Project No. 402.065883.00001

**RE: Flood Resilience Measures Planning Application: PL/2025/07023
Ecological Response: Justification for Exemption from Biodiversity Net
Gain (BNG) Requirements**

Wiltshire Council request for further information

Figure 1: Area of woodland referred to within this response.

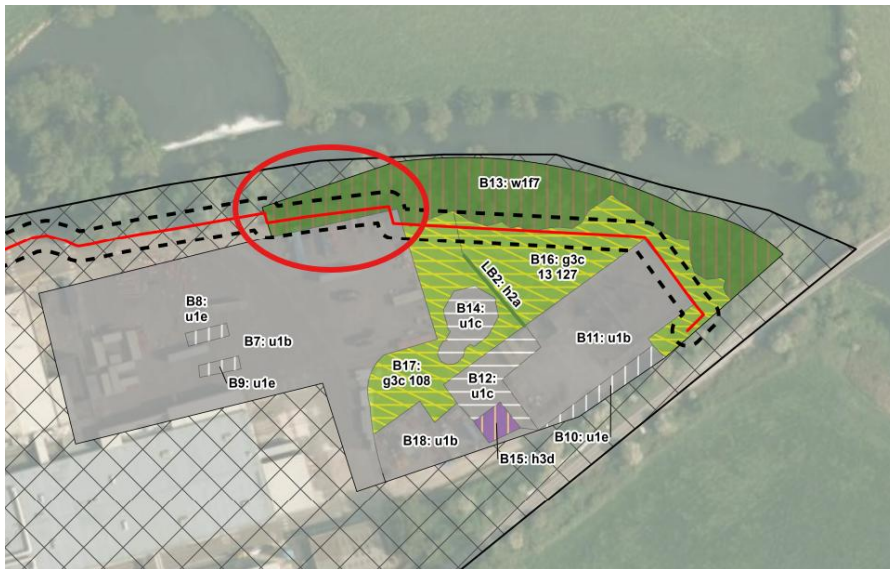
*“The EcIA states that BNG is not required under the de minimis principle as the development site is under 25 square metres and no priority habitat is being lost. We note that the new kerb passes through an area of woodland identified on Figure 1 of the EcIA, the UK Habitat Baseline: **further information is required to measure the woodland habitat impact loss and the grassland habitat impact/loss to confirm whether the BNG de minimis principle can be applied.**”*

It is assumed that this comment refers to the location circled in red below (see Figure 1).

The area where the proposed flood defence kerb is shown as passing through woodland does not comprise trees or woodland ground flora. This area is instead characterised by tree canopy over silt above heavily managed, species-poor grassland, with no woodland understory present (see Figure 2). This is a mapping artefact arising from the UK Habitat Classification-down assessment method, as the area is mapped as woodland due to canopy cover despite the underlying habitat being managed grassland.

Although the works lie within the root protection areas (RPAs) of adjacent trees, the ground is heavily managed, compacted, and located adjacent to existing hardstanding. As such, no loss of woodland habitat, woodland soils, or priority vegetation will occur as a result of the works. Appropriate measures detailed within the CEMP will be implemented to ensure tree roots are protected and that no damage occurs to existing features of ecological value.

On this basis, the works will not result in a measurable loss of woodland or grassland habitat, and it is considered that the Biodiversity Net Gain de minimis exemption remains applicable.
